FOREST RESIDENTS OPPOSING NEW TRANSMISSION LINES

Subject: Comments by Forest Residents Opposing New Transmission Lines Regarding
the "Request for Additional Information and Comments on Study Plans"
Issued by the Commission to The Nevada Hydro Company

Reference: Commission Letter Dated January 22, 2019 in Docket P-14227

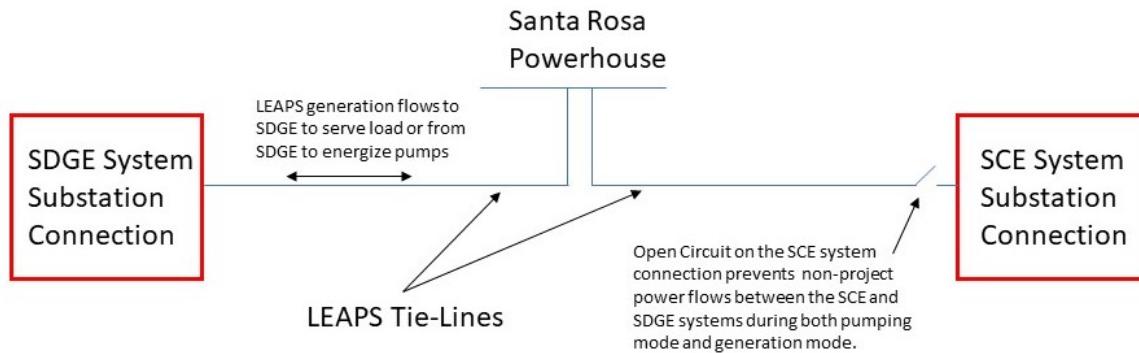
It is axiomatic that power does not flow on a transmission line if one end of the line is "open" because an "open" circuit does not permit power to flow. "Closing" and "opening" a transmission line is typically done with circuit breakers and switches; "open" circuit breakers prevent power flow and "closed" circuit breakers permit power flow. By extension, power will flow between two connection points when both connections are "closed" and it is inhibited when one connection is "opened". Accordingly, the only way to license LEAPS with two connections and prevent non-LEAPS power flows between these connections (as mandated by the FPA) is to require that at least one connection remain open at all times. This configuration will result in the following operating profiles:

Transmitting Power to and From SCE's System:

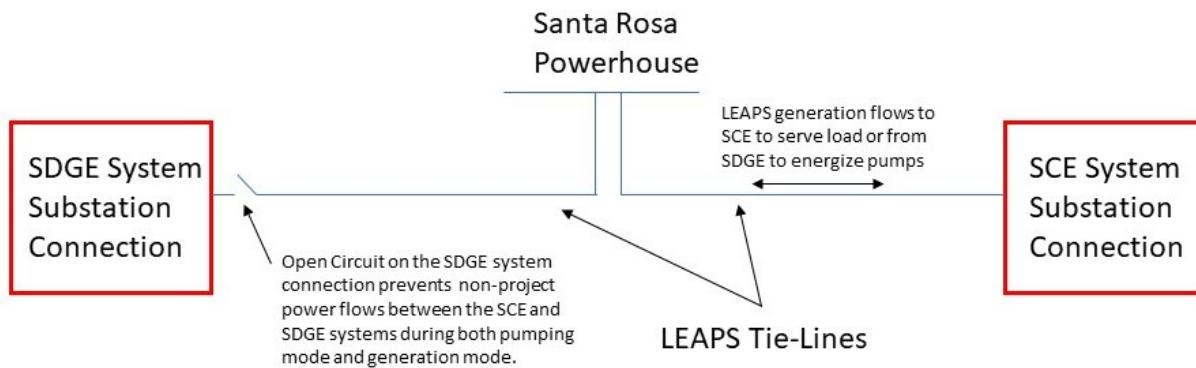
Closing the SCE connection to LEAPS while maintaining the SDGE connection in an open configuration will send LEAPS-generated power to SCE and provide LEAPS with power from SCE to recharge the upper reservoir without transferring "grid" (non-LEAPS) power between SCE and SDGE.
